PROJECT: Summerlin West 1/2 - Kestrel Creek Avenue (Street 1)

CITY OF LAS VEGAS INTER-OFFICE MEMORANDUM

Drainage Study for:

Summerlin West V22 – Kestrel Creek Avenue (Street I)
(from Desert Foothills Drive to Kettle Ridge Drive <Street J>)

STORM DRAIN LATERAL PROFILE

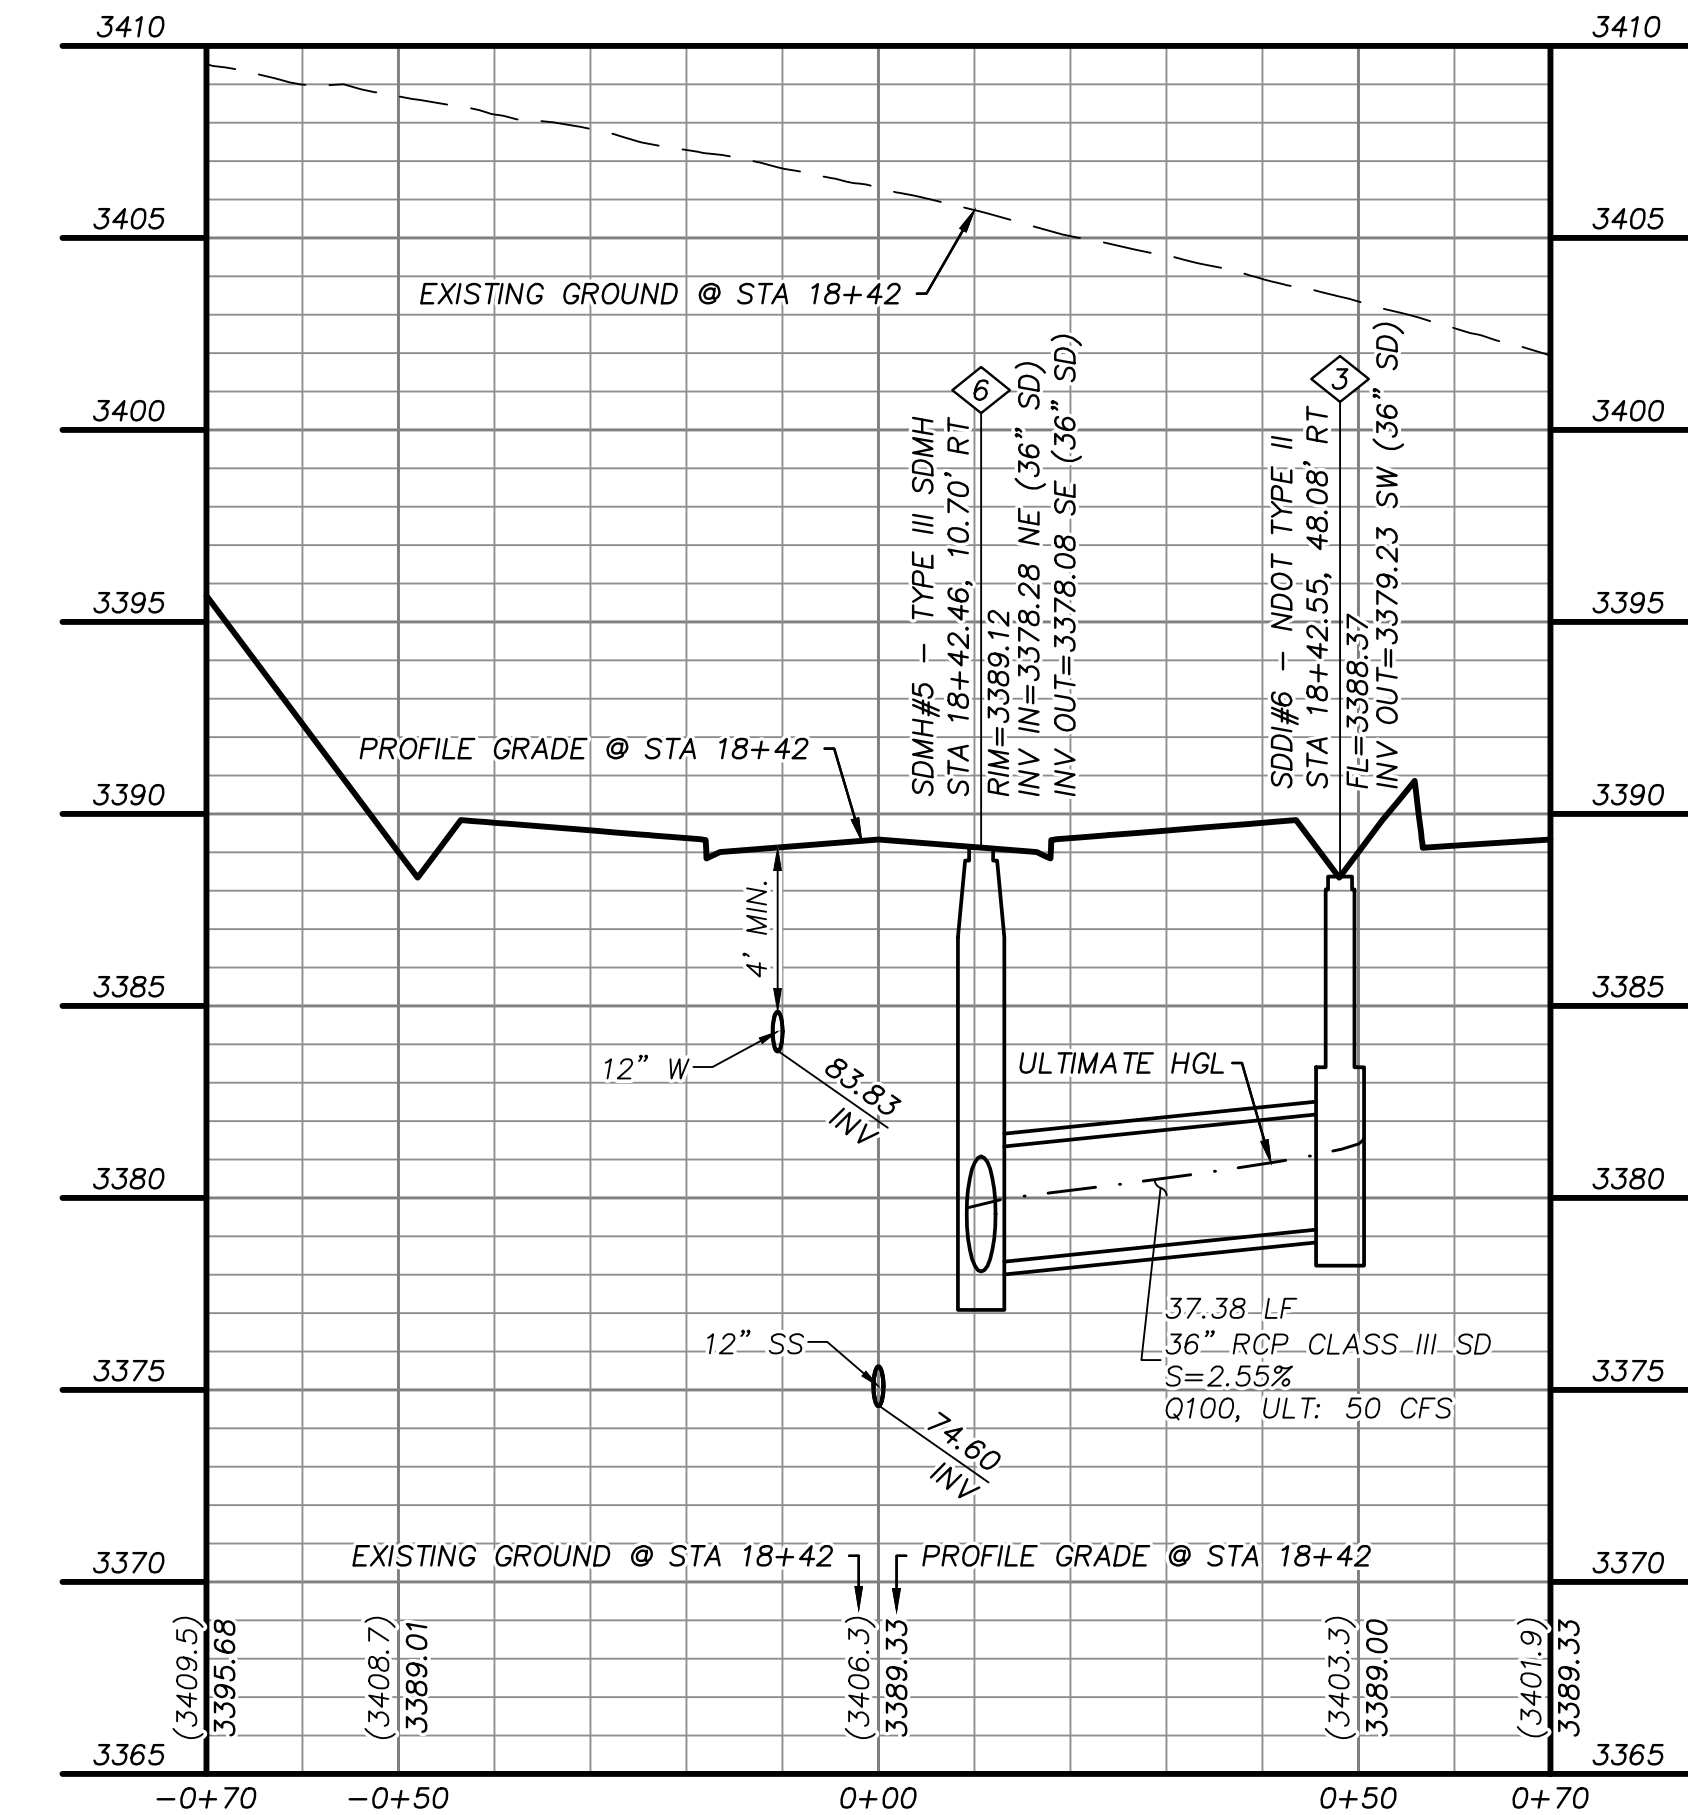
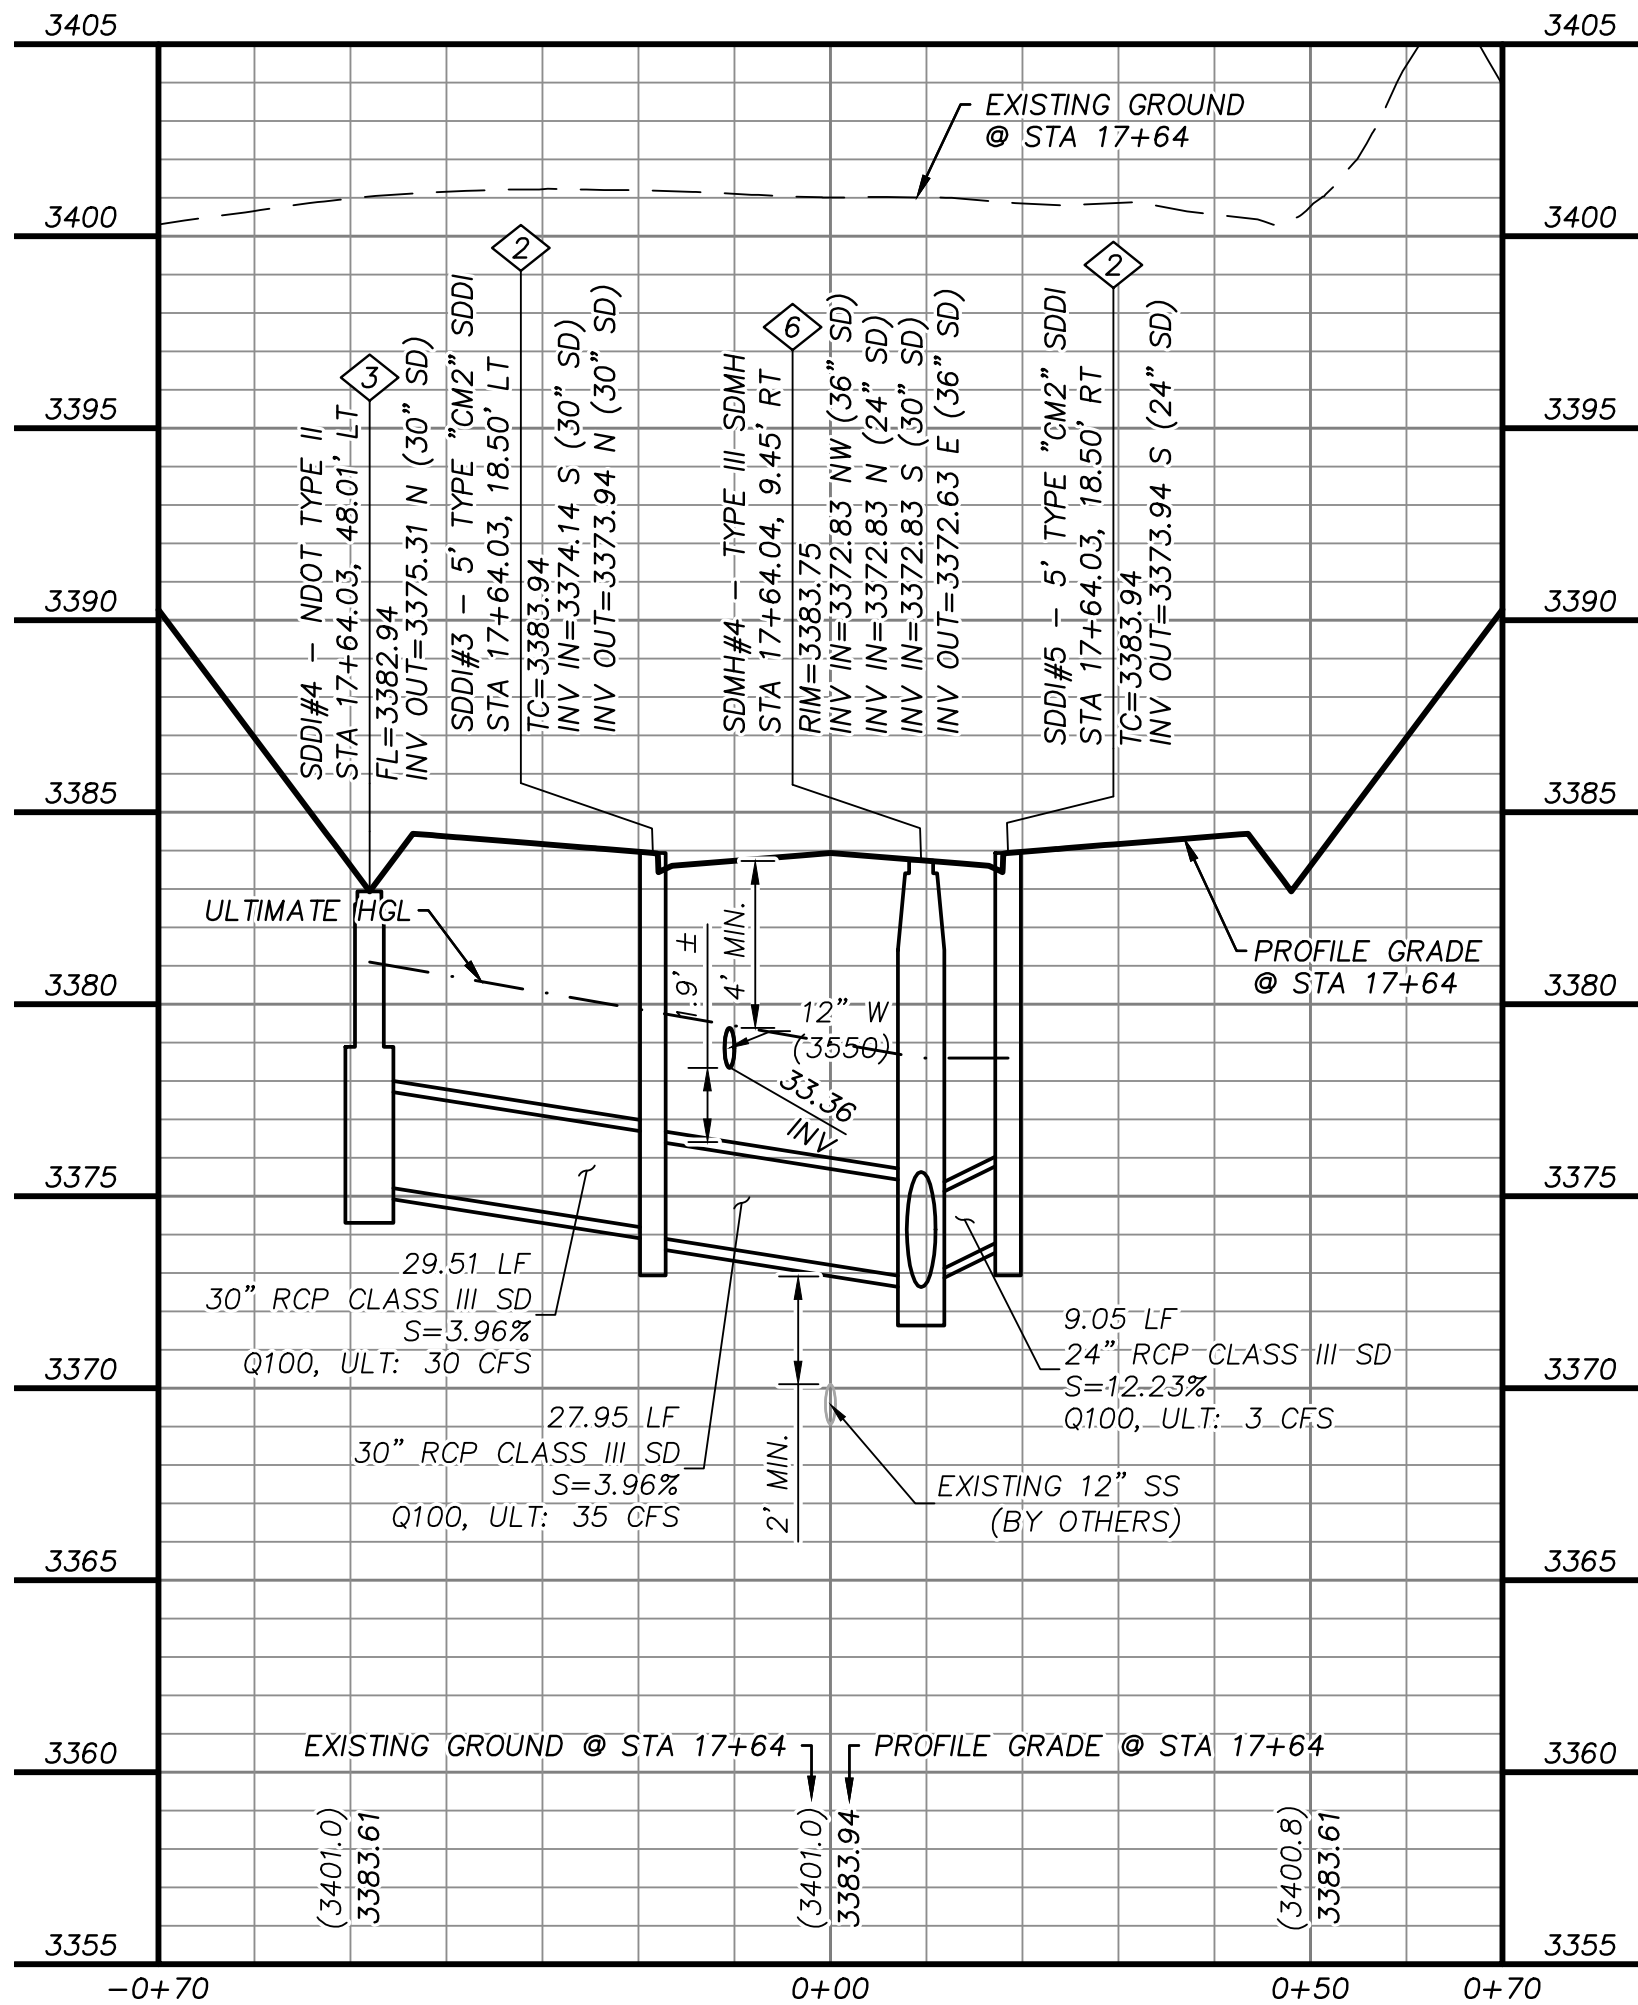
The response that all drop inlets had been modified to less than 10' in depth was found not true. Per **Sheet 21/31 (Storm Drain Lateral Profiles)**, proposed inlets SDDI #1, SDDI #3 and SDDI #5 are schematically shown to be deeper than 10'. This must be resolved prior to the final approval of the study.

On Sheet 21/31, since you did not label the depth of the inlets clearly, I went on visually measuring the depths from the profile and found that the inlets are more than 10' deep from the flow line to the bottom. So label the depth of each inlet clearly and revise the profile to visually convincing.

The response that all drop inlets had been modified to less than 10' in depth was found not true. Per Sheet 21/31 (Storm Drain Lateral Profiles), proposed drop inlets SDDI #1, SDDI #2, and SDDI #4 are schematically shown to be deeper than 10'. This must be resolved prior to the final approval of the study.

Drop Inlet	Top of Curb	Flow Line	Invert	Depth
SDDI #1	3440.17	3439.67	3329.75	9.92'
SDDI #3	3383.94	3383.44	3373.94	9.50'
SDDI #5	3383.94	3383.44	3373.94	9.50'

Please review the above information and methodology and let us know if we can issue a formal supplement if a formal supplement is necessary to clear up this discrepancy and hopefully move closer to conditional approval.
